Informal document **GRVA-04-03**
4th GRVA, 24-27 September 2019
Provisional agenda item 6(a)

Regulation ECE R79-03

ACSF C 2-Step HMI

Justification for the timing between
First action and Lane Change Manoeuvre at 7 seconds

Results

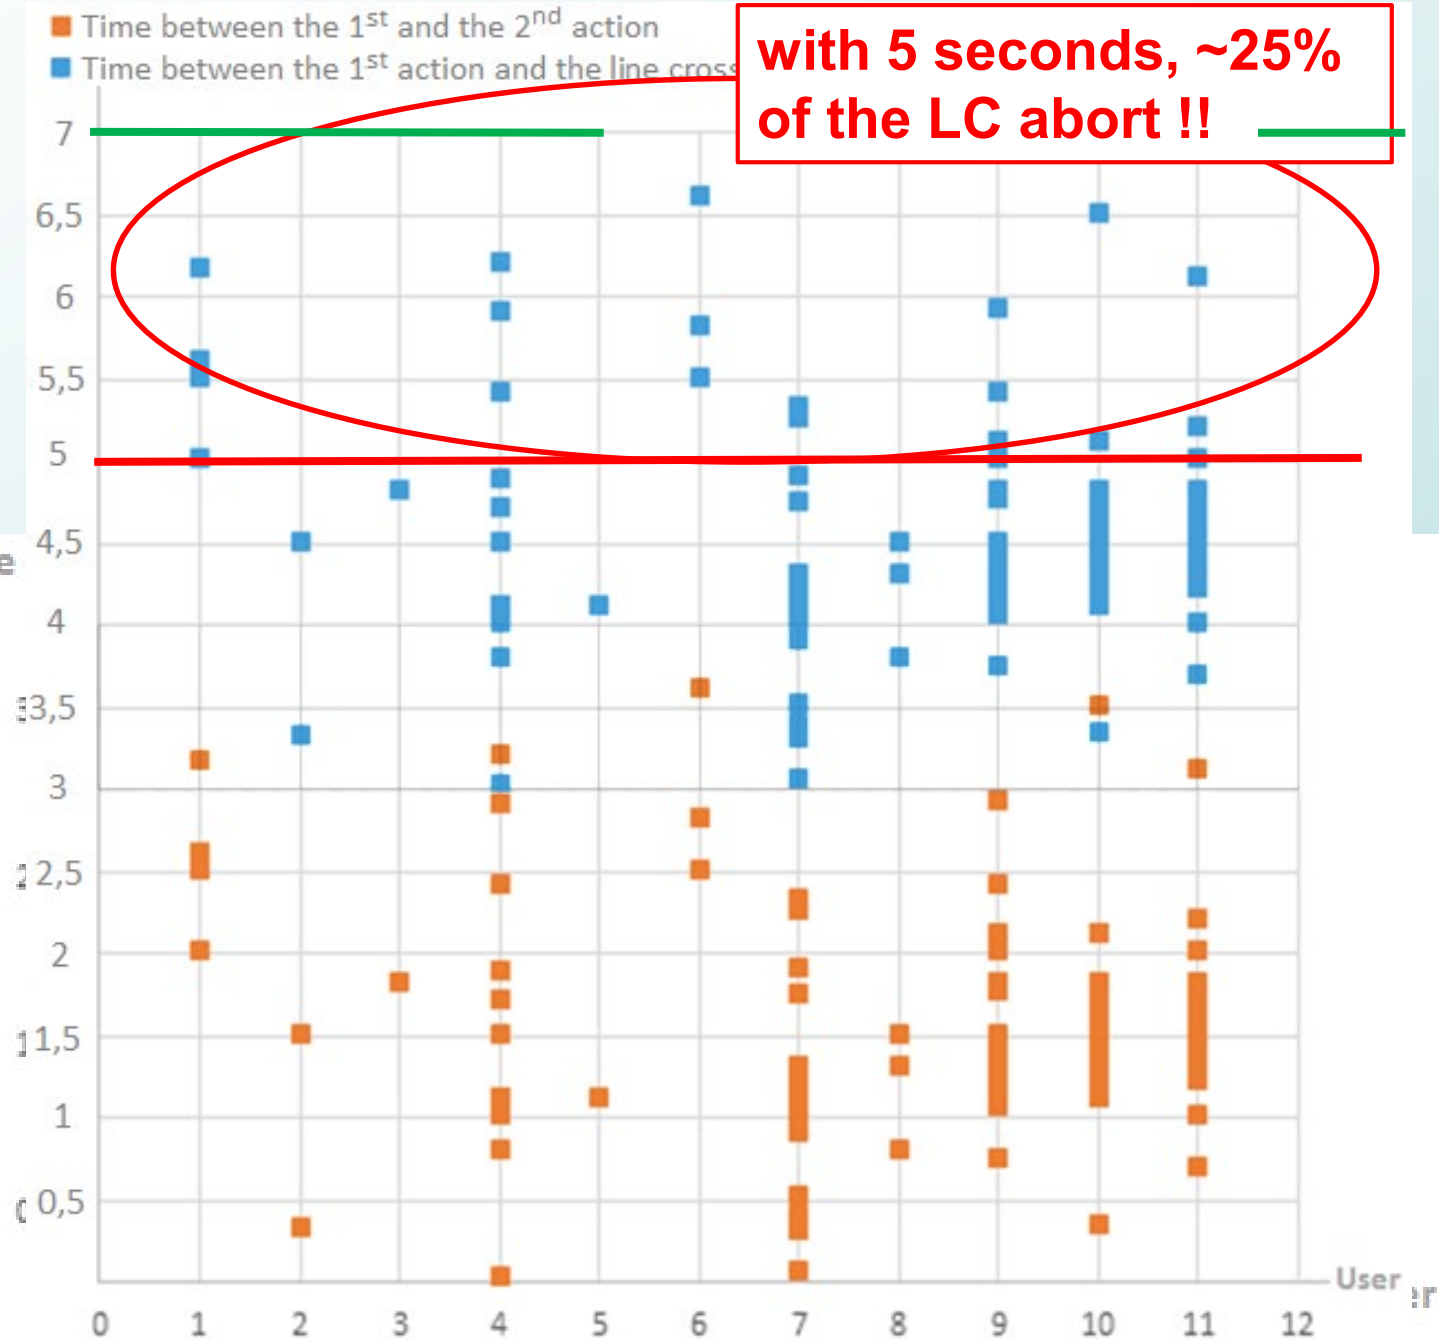
7 seconds are needed !!

Time between the First and the second deliberate action + 3 seconds*

- There will be a significant percentage (up to 23%) of lane change manoeuvre aborted if the time between the **1st action** and the **line crossing** is limited to 5 seconds

OICA then propose limiting the timing between the first deliberate action and the Lane Change Manoeuvre to 7 Seconds
